ATTACHMENT B

MARKED UP PAGES FOR PROPOSED CHANGES TO APPENDIX A TECHNICAL SPECIFICATIONS OF FACILITY OPERATING LICENSES NPF-72, AND NPF-77

BYRON STATION UNITS 1 & 2 REVISED PAGES:

FIGURE 3.4-1
DOSE EQUIVALENT I-131 REACTOR COOLANT SPECIFIC ACTIVITY
LIMIT VERSUS PERCENT OF RATED THERMAL POWER WITH THE REACTOR
COOLANT SPECIFIC ACTIVITY $> 1 \mu\text{Ci}/\text{GRAM}$ DOSE EQUIVALENT I-131*

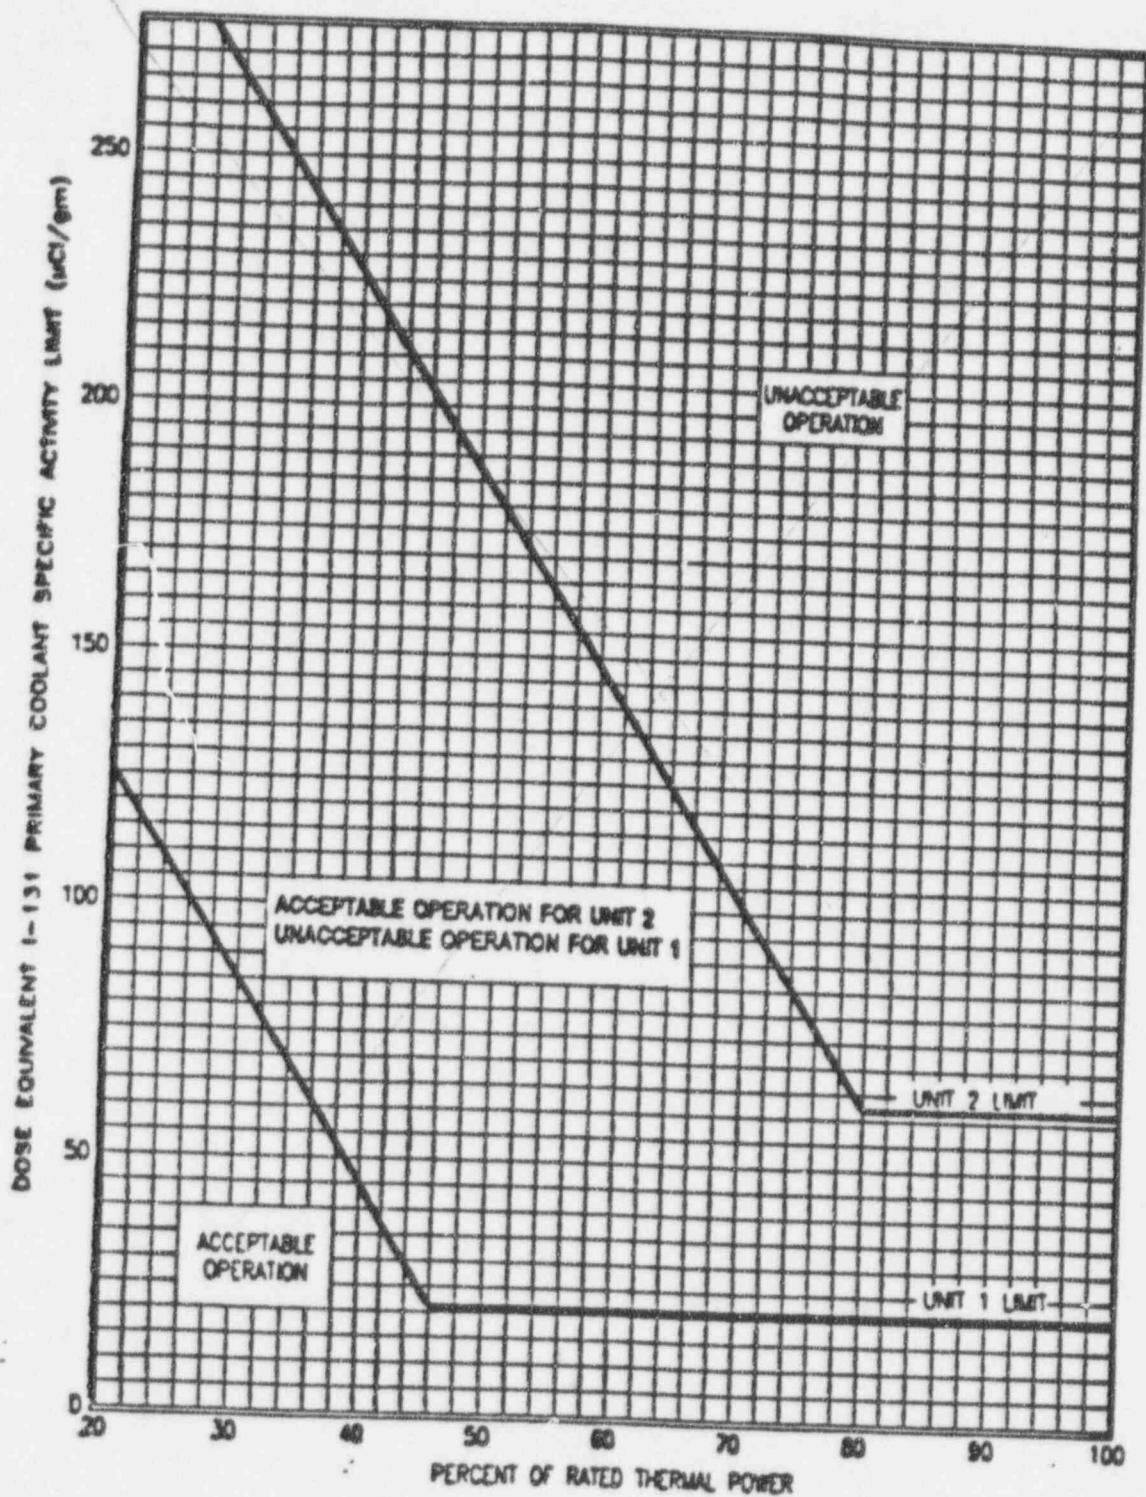
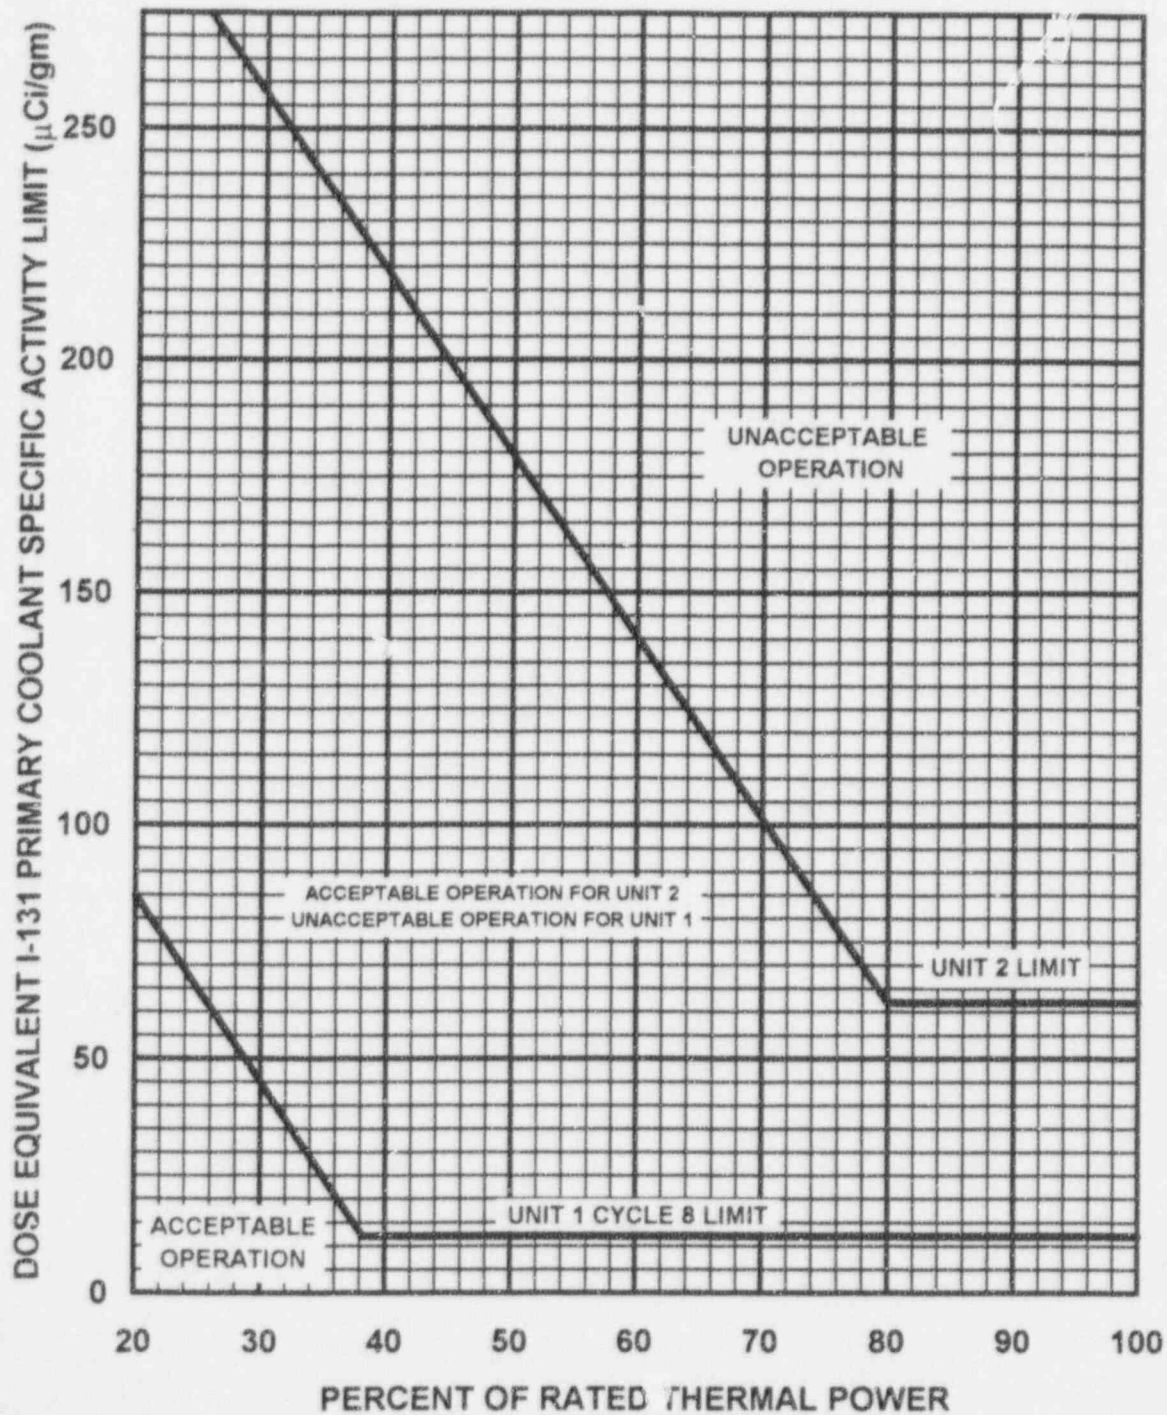
*For Unit 1, Reactor Coolant Specific Activity $> 0.35 \mu\text{Ci}/\text{Gram}$ DOSE EQUIVALENT I-131

* For Unit 1 through Cycle 8, Reactor Coolant Specific Activity $> 0.2 \mu\text{Ci/Gram}$ DOSE EQUIVALENT I-131.

1. The proposed licensing action involves the issuance of an amendment to a license for a reactor pursuant to 10 CFR 50 which changes a requirement with respect to installation or use of a facility component located within the restricted area, as defined in 10 CFR 20, or which changes an inspection or a surveillance requirement. This revision will lower the Reactor Coolant System Dose Equivalent Iodine 131 limit from 0.35 microCuries per gram to 0.20 microCuries per gram. This revision will also lower the Reactor Coolant System Dose Equivalent Iodine 131 limit in Technical Specification Figure 3.4-1. These revisions will be in effect for the remainder of Unit 1 Cycle 8;
